**RE: Response to Assessment Report**  
**Ppty: Roseville Memorial Club – DA0134/18 | PPS-2018SNH040**

Thank you for the opportunity to provide this response to the Assessment Report dated 10 August 2020 as prepared by Ku-ring-gai Council, scheduled for a Sydney North Planning Panel (SNPP) teleconference on September 2, 2020.

**RE: Response to Assessment Report**  
**PPty: Roseville Memorial Club – DA0134/18 | PPS-2018SNH040**

## **Appendix 4 – Street Wall**

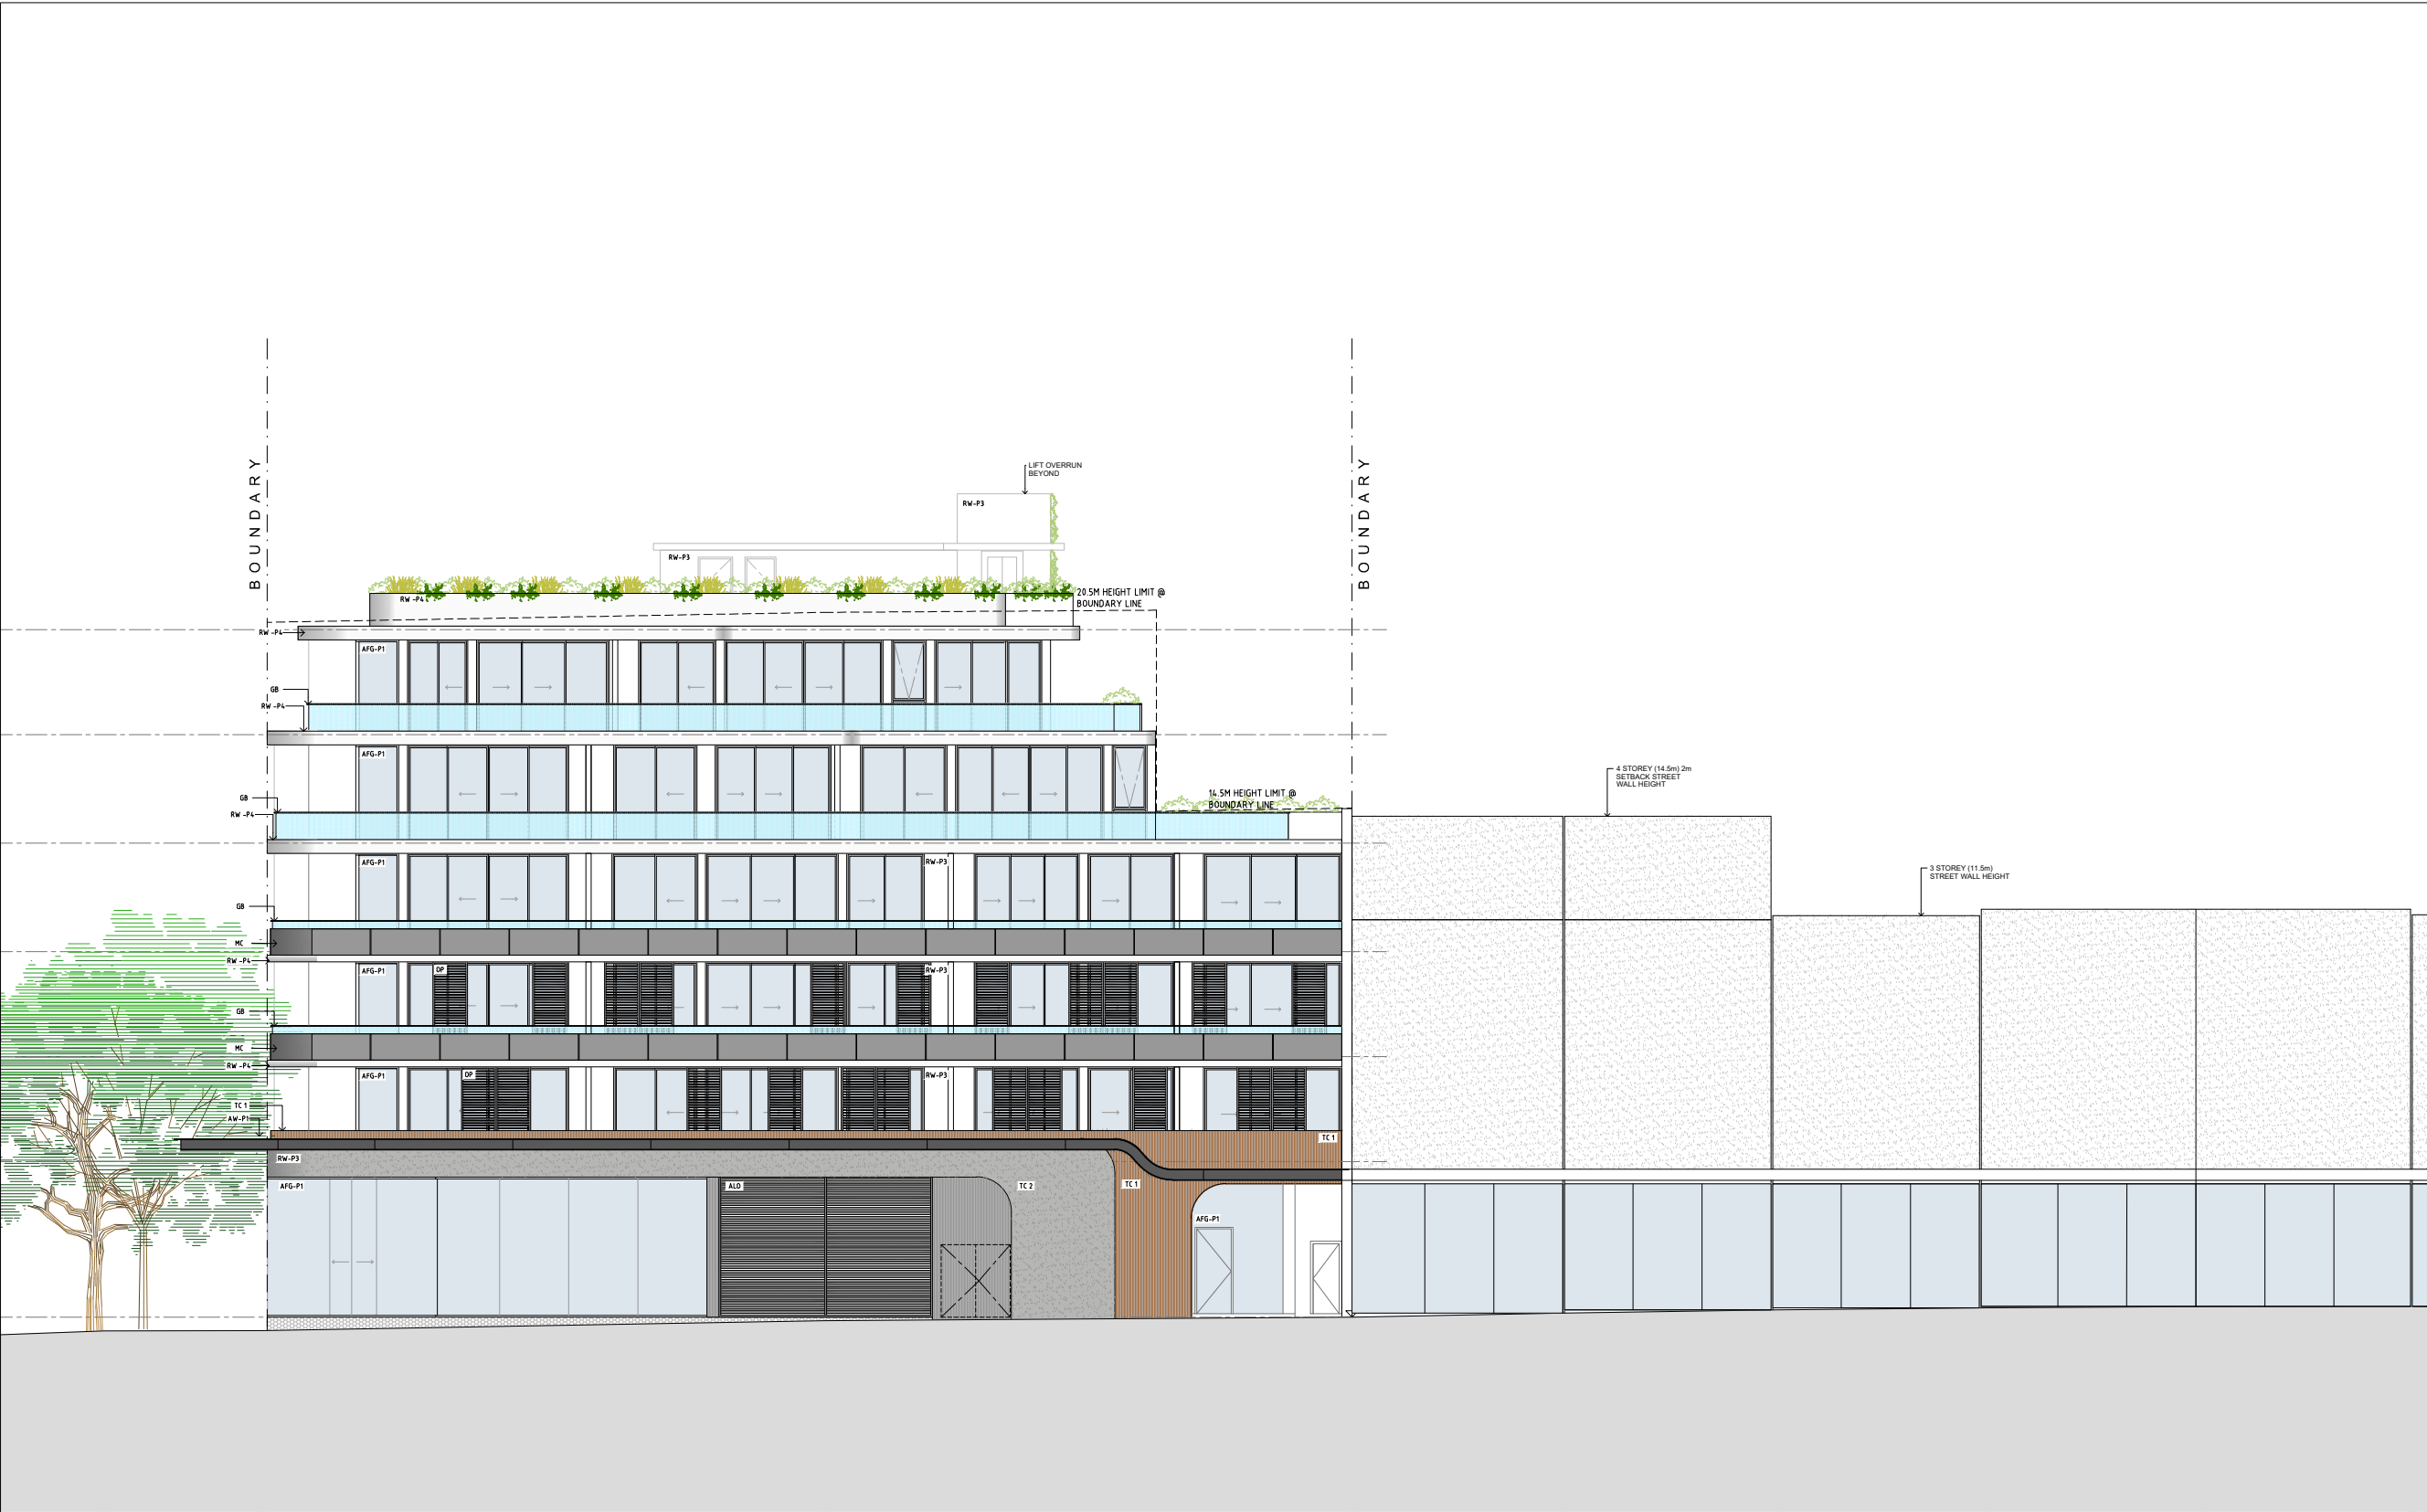
**Point 10 – Street Wall Requirement**

- The images below show the future potential development which may occur to the north of the Site along Pacific Hwy. These images show the merit of the proposed design which, by flexibility of the street wall requirement of the DCP, has allowed a landmark building to be designed on the corner, providing an anchor role in accordance with the following clause 7 (vi) of the DCP *‘Design a landmark corner building for the site adjoining Memorial Park’* that will transition to the neighbouring future development as well as Section 14F.9 Precinct R2 *‘Roseville cinema and the RSL provide an anchor role’* (Additional 3D views can be seen in **Appendix 2**)

*Shows the street wall height with the future potential development to the North*

## **Appendix 6 – Unit 403**

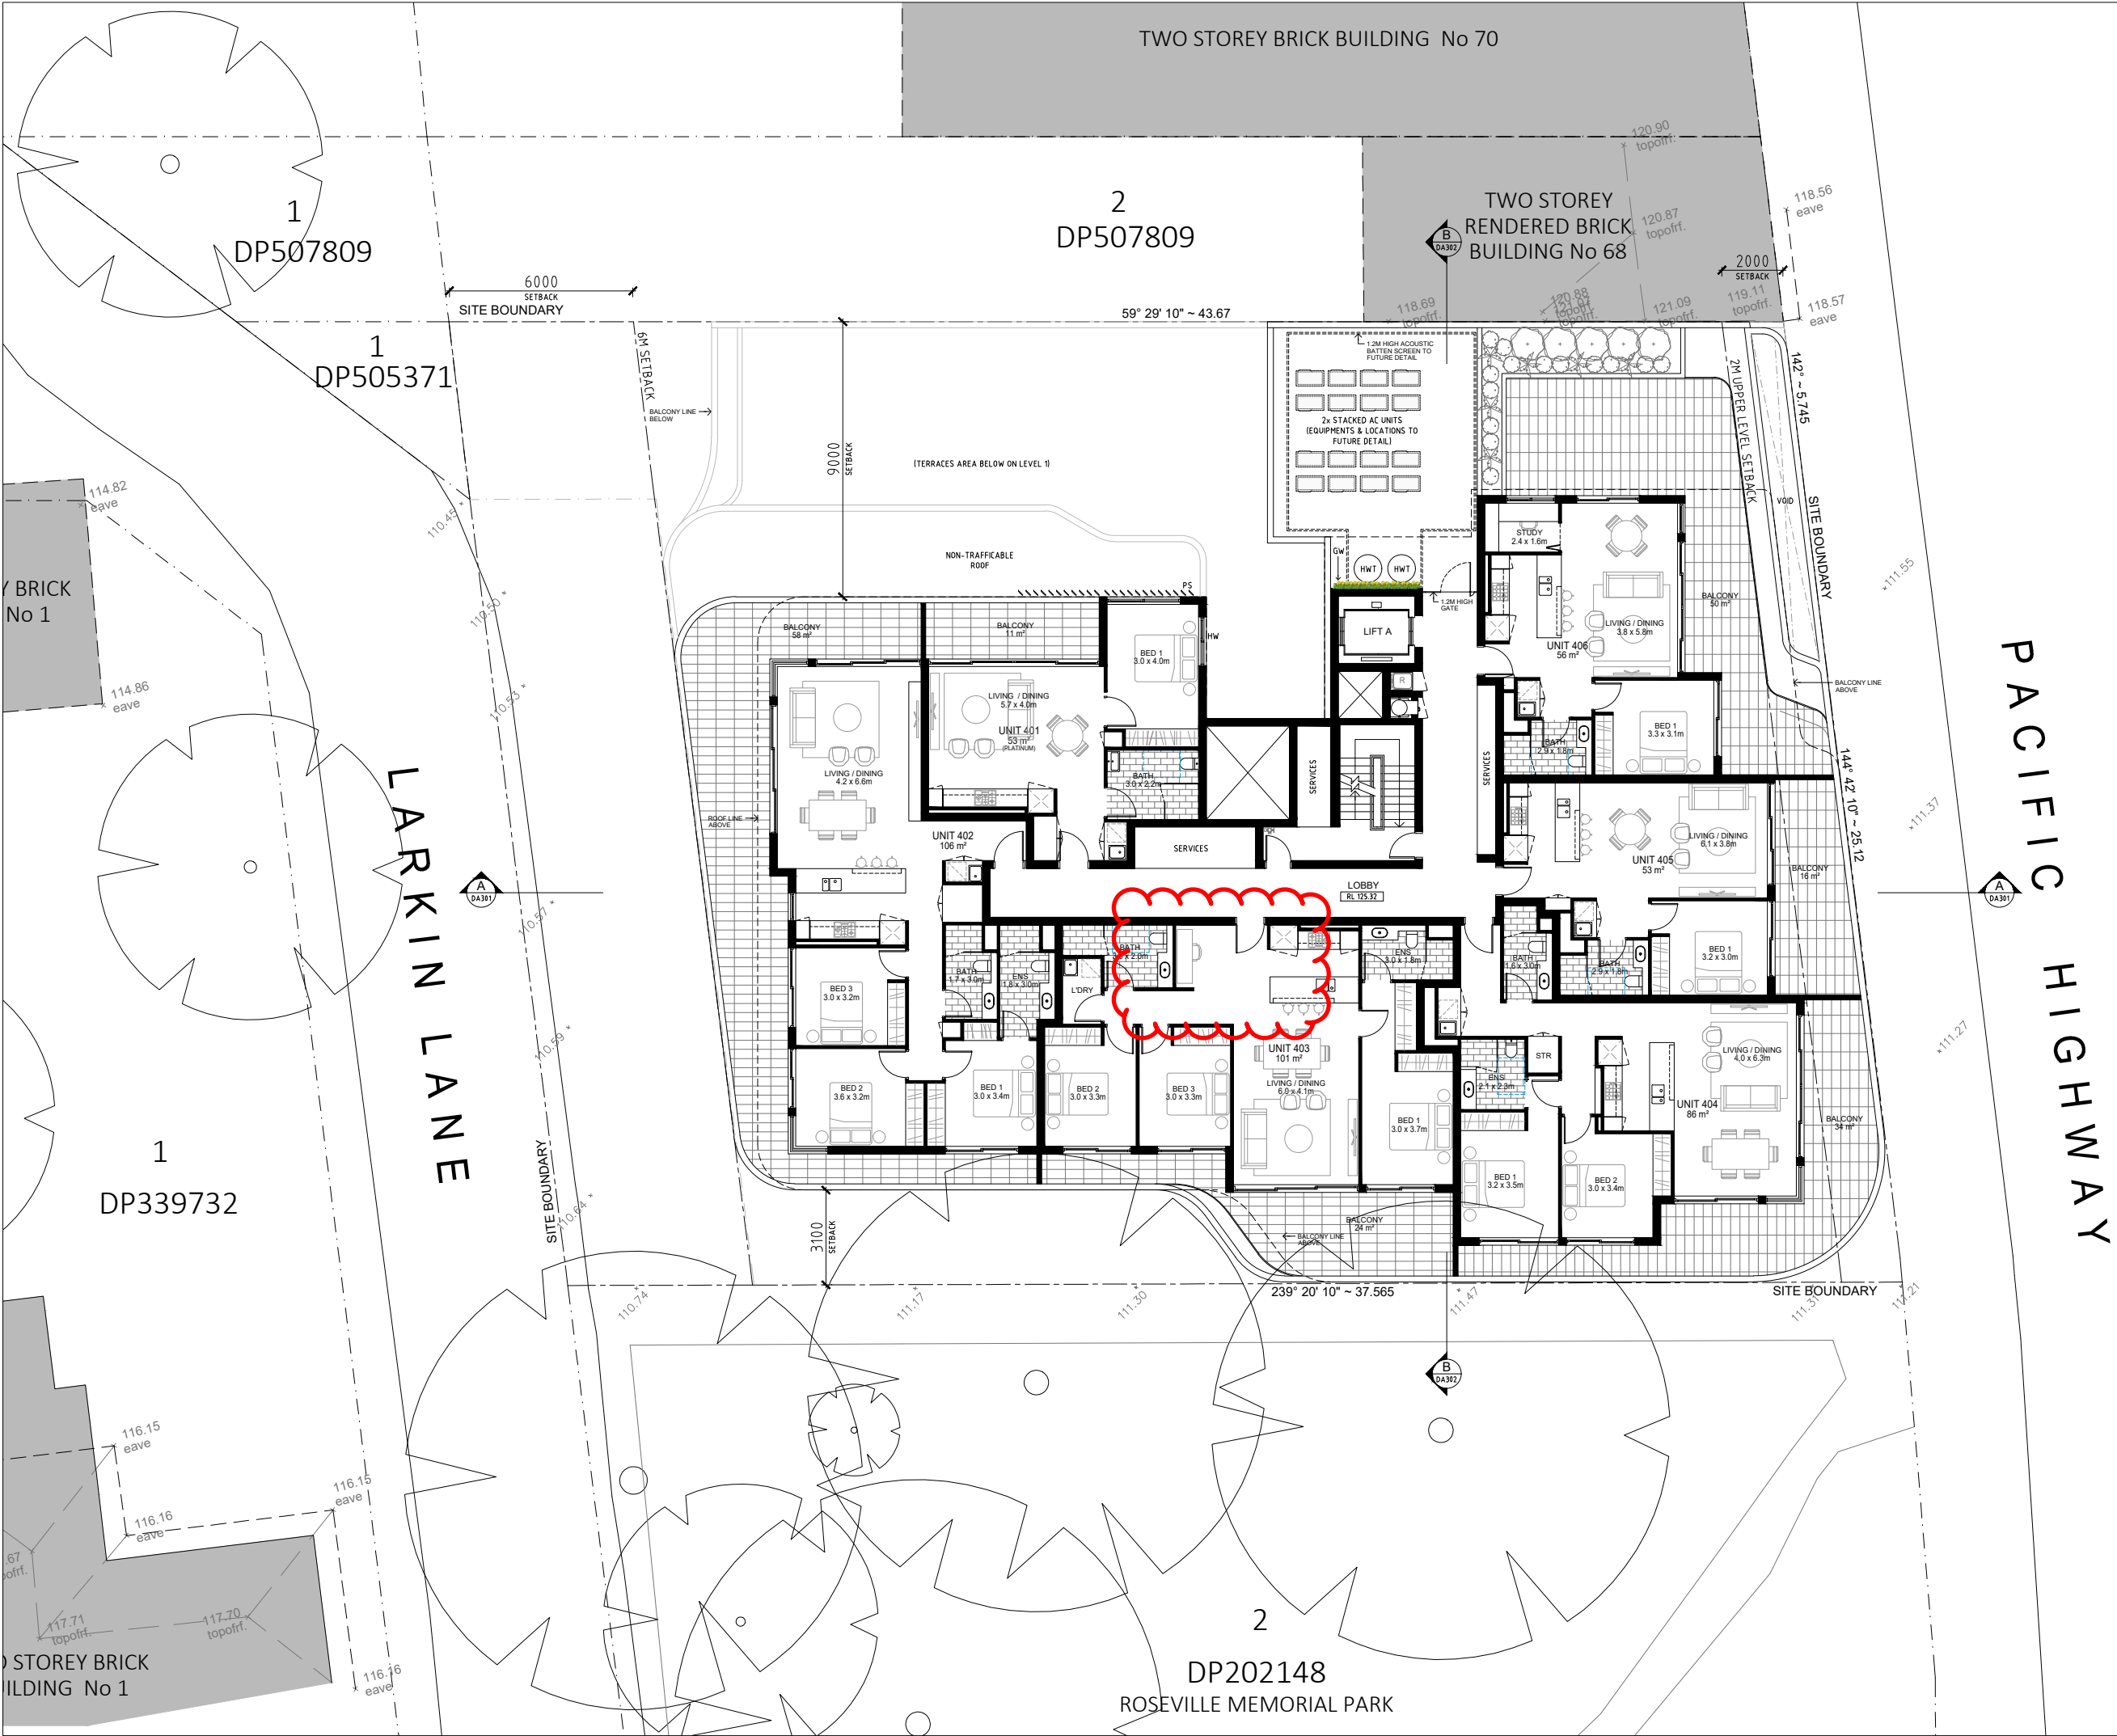
- This issue can be addressed by a condition requiring a minor amendment to the architectural plans to reflect the removal of the enclosed study wall. We would accept such a condition.
- A copy of the proposed redesign can be found in **Appendix 6**.
